# UNITED STATES PATENT AND TRADEMARK OFFICE

APPLICATION NO.	FILING DATE	FIRST NAMED INVENTOR	ATTORNEY DOCKET NO.	CONFIRMATION NO.
10/660,135	09/11/2003	Manfred Brinkmann	7236	6900

## Office Action Summary

### DETAILED ACTION

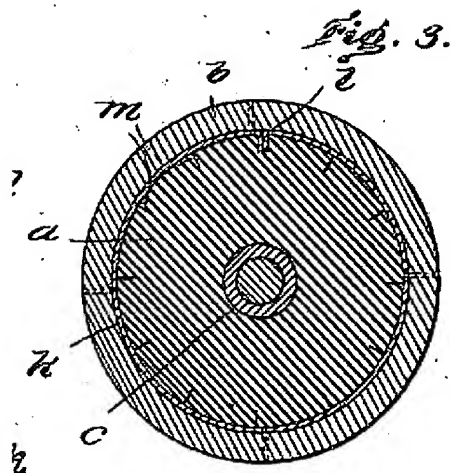
With reference to Figures 2 and 4, Field discloses the claimed invention including: a) a pad holder 22; b) a frame 14; c) an abrasive 23 slipped over said pad holder 22.

Please note that the functional limitations of "characterized in that ... to be sanded" has been considered but was found to be inherent in the prior art tool because the abrasive backing 16 is made of rubber. However, Field does not disclose that pad holder 22 is made of elastic material.

It would have been obvious to one having ordinary skill in the art at the time the invention was made to have modified to have utilize the elastic material since it has been held to be within the general skill of a worker in the art to select a known material on the basis of its suitability for the intended use as a matter of obvious design choice. Regarding to claims 11-12, as well as understood due to the drawing objection above, Field appears to show these limitations in Figure 2.

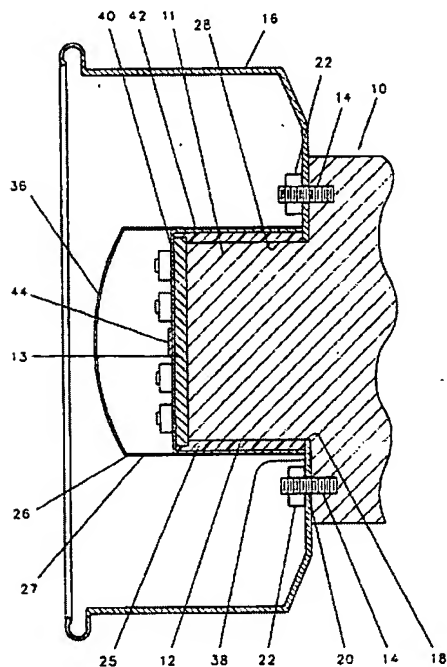
With reference to Fig. 3, Polka discloses frame 10 having a central hub 16, a seat ring 25, and end ring 13.

Field discloses the claimed invention except that a threaded shaft instead of a hub.

Polka shows that a hub is an equivalent structure known in the art to attachably install an article to a rotational spindle (a tool in Field and a tire in Polka). Therefore, because these two elements were art-recognized equivalents at the time the invention was made, one of the ordinary skill in the art would have found it obvious to substitute a threaded shaft for a hub.
